**Re: Data Adequacy Supplement, CPV Vaca Station (08-AFC-11) Application for Certification**

*Application for Certification*  
**Supplement in Response to  
Data Adequacy Review**

# CPV Vaca Station

(08-AFC-11)

**FIGURE DA 3.0-1**  
**PROJECT AND SWITCHYARD ONE-LINE DIAGRAM**  
 CPV VACA STATION  
 VACAVILLE, CA

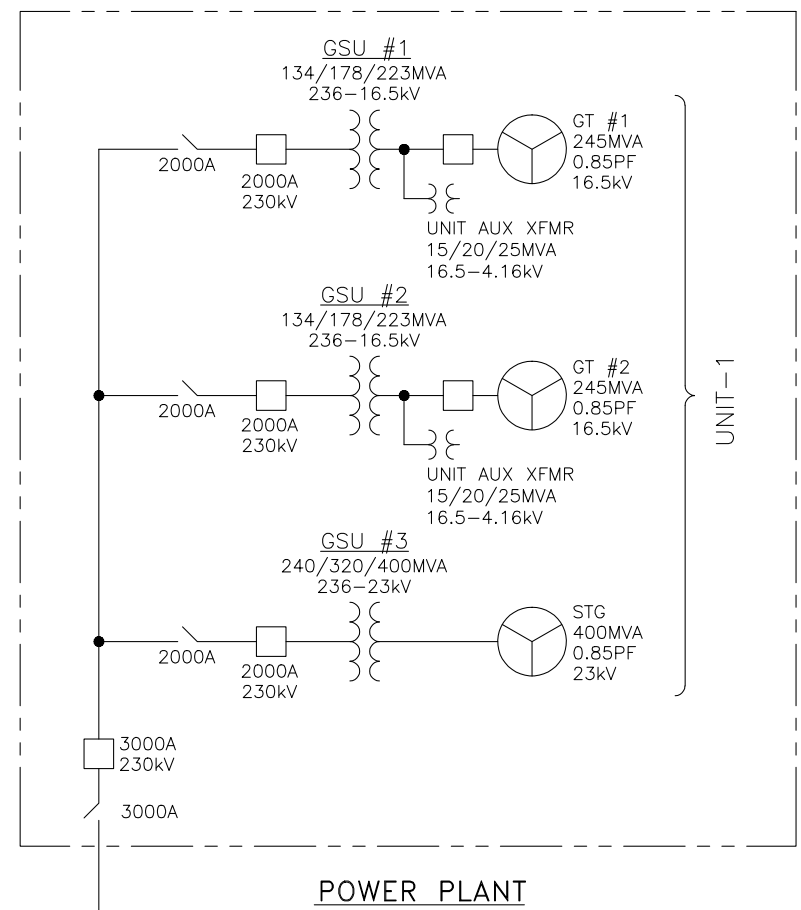
- 4. Please resubmit Figure 3.2-2, Energy Facility One-Line Diagram. Show all equipment ratings including bay arrangement of the breakers, disconnect switches, buses, and generation tie-lines, etc. which are required for the addition of the project (information provided in the AFC and the System Impact Study is inconsistent).*

Figure DA3.0-1 is a local system one-line diagram showing the electric transmission system in the vicinity of the CPVVS. Figure DA3.0-2 shows typical pull-off H-frame structure in the interconnection switchyard and at the power plant substation, typical dead-end pole, and typical transmission pole design that could be used for the transmission line.

The proposed interconnecting 230-kV transmission circuit will be designed in double (or, optionally, single) circuit configuration, supported by steel-pole structures at appropriate intervals. The transmission line will consist of double 1590 kcmil ACSR (Falcon) or, optionally, single 1780 kcmil ACSS (Chukar/ACSS) conductor(s) per phase.

**FIGURE DA 3.0-2  
DETAIL DRAWINGS OF TYPICAL TAKE-OFF STRUCTURE,  
DEAD-END STRUCTURE, AND TRANSMISSION POLE  
CPV VACA STATION  
VACAVILLE, CA**

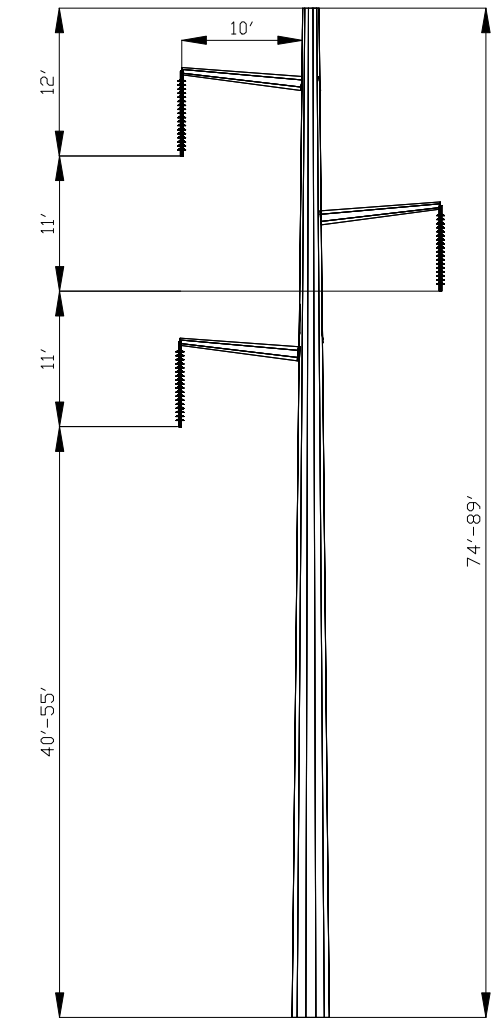
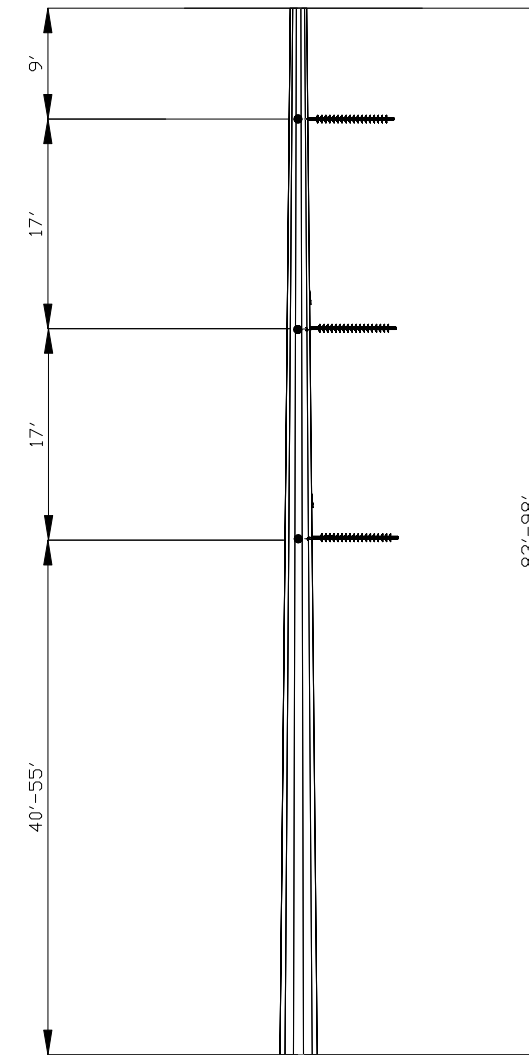
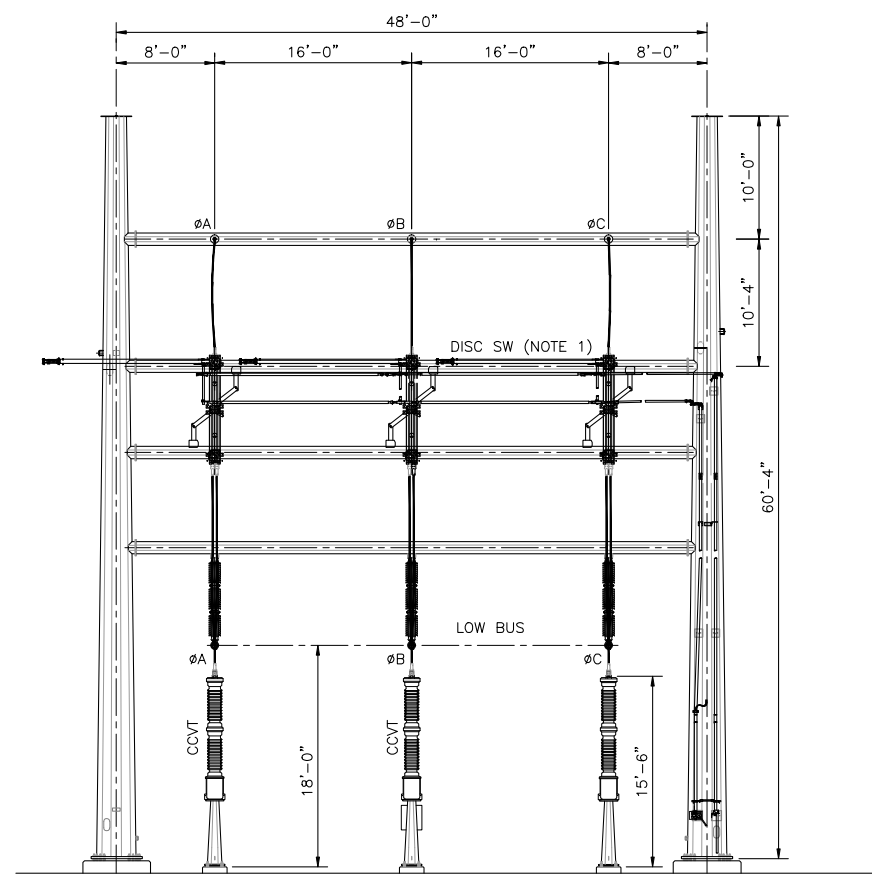
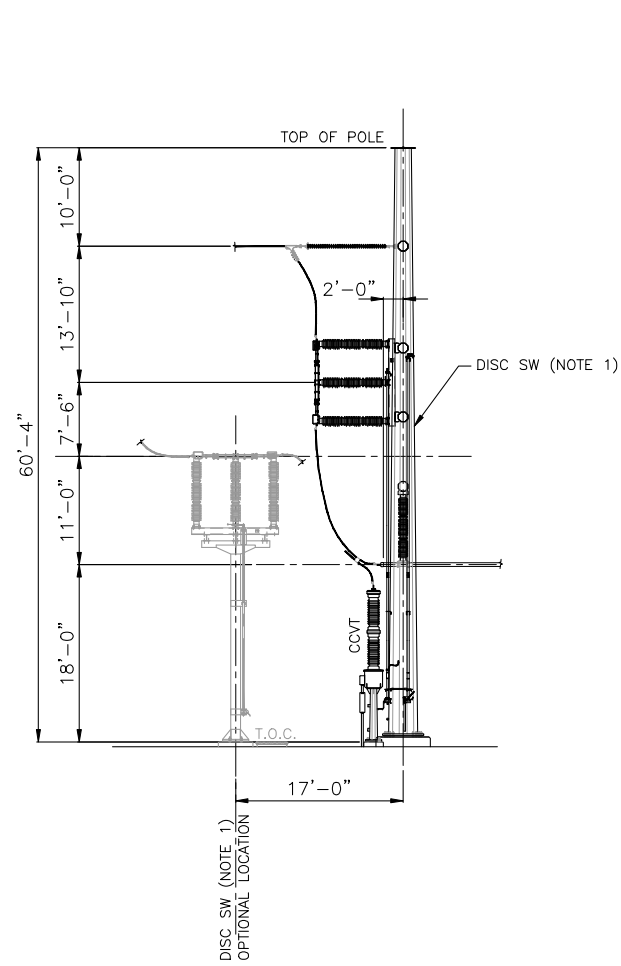
- 1. Please provide detail drawings for the take off structures required for interconnecting the one-mile long generation tie-lines from the power plant to the new switchyard.*

- 2. Please provide detail drawings for the dead-end structure and 230 kV transmission poles required for the transmission lines to loop-in and loop-out of the new project switchyard.*

The proposed line will exit the CPVVS onsite switchyard in a slack span configuration from the take-off structures. The exit span will vary in length to accommodate the route option selected and will connect the pull-off structures to a new steel-pole, heavy-angle structure. The heavy-angle structure will be constructed to accommodate the turn necessitated by the

**FIGURE DA 5.12-1**  
**AIRPORT LOCATIONS**  
 CPV VACA STATION  
 VACAVILLE, CA

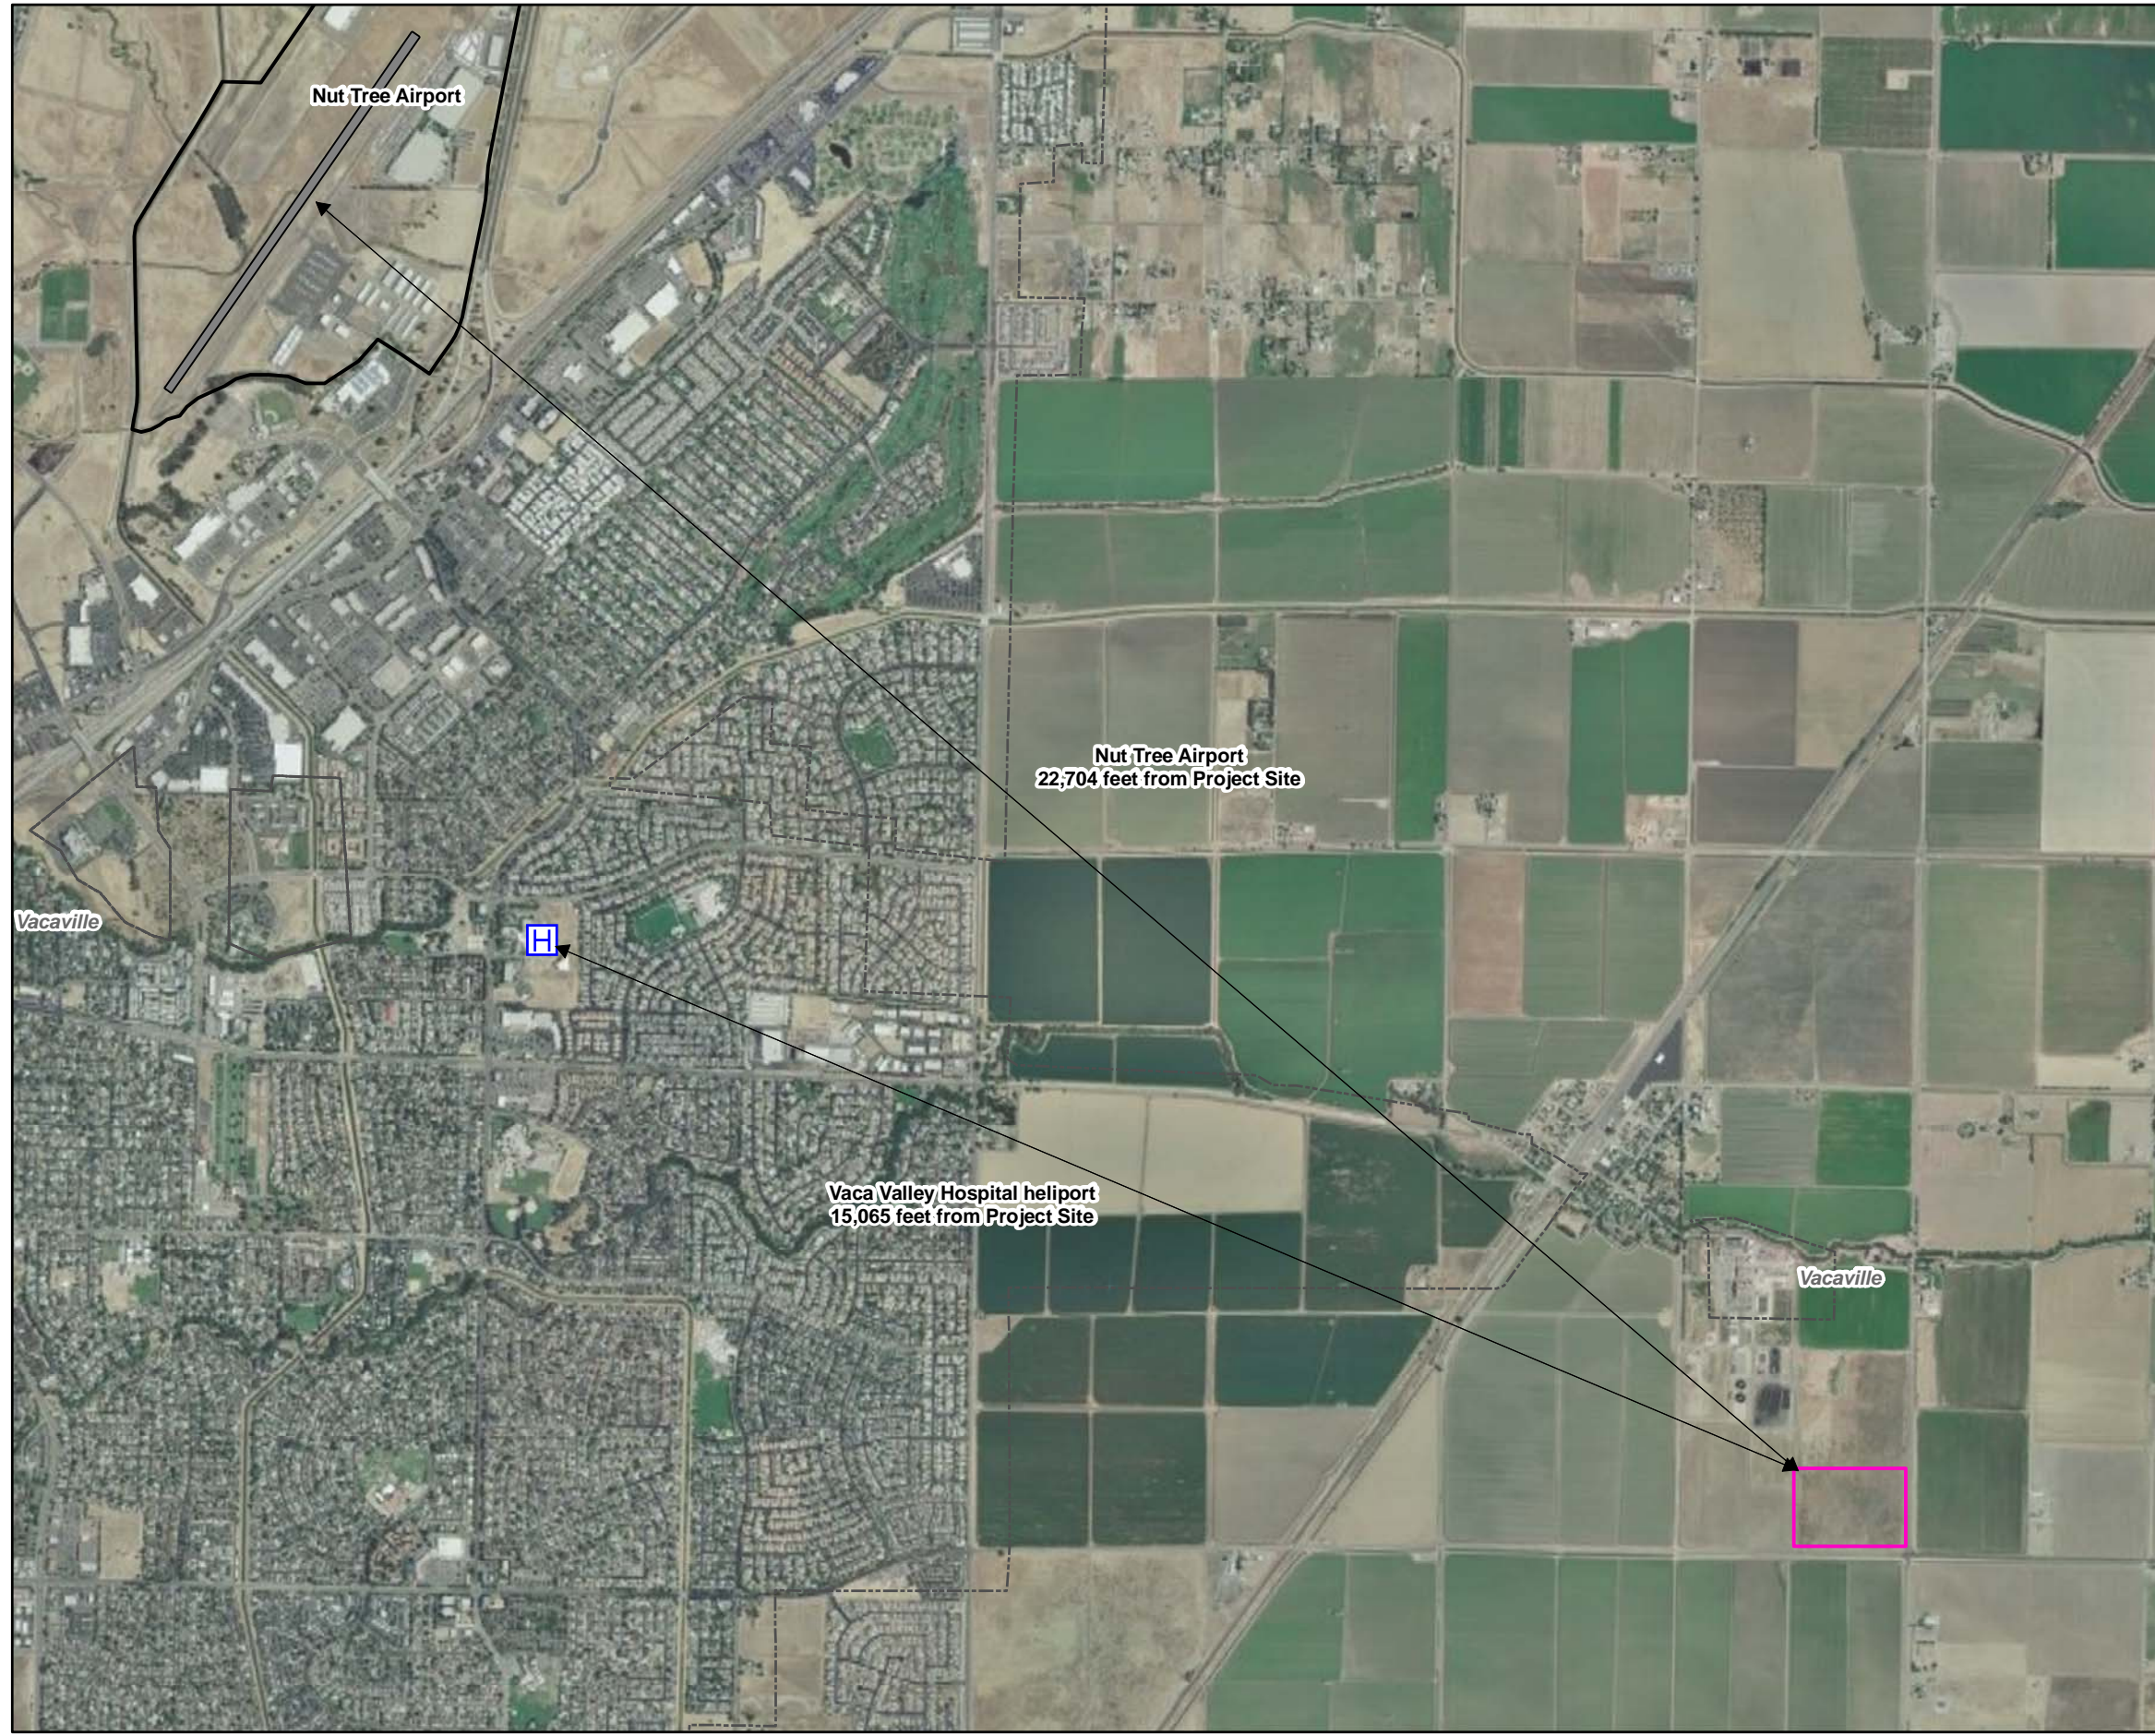
*Please clarify if the proposed project including any linear facility is to be located within 20,000 feet of an airport runway (e.g., at Travis Air Force Base) that is at least 3,200 feet in actual length, or 5,000 feet of a heliport (or planned or proposed airport runway or an airport runway under construction, that is the subject of a notice or proposal on file with the Federal Aviation Administration). If there are proposed power plant site and related facilities within 20,000 feet, as stated, please provide a map at a scale of 1:24,000 that displays the airport or airstrip runway configurations.*

Measuring from the southern boundary of the CVPVS site to the northern end of the Travis Air Force Base runway, the distance is 20,592 feet. The relationship of the project site to the Travis Air Force Base and Nut Tree Airport is depicted on AFC Figure 5.12-1. Figures DA5.12-1 and DA5.12-2 show this more clearly at a scale of 1:24,000.
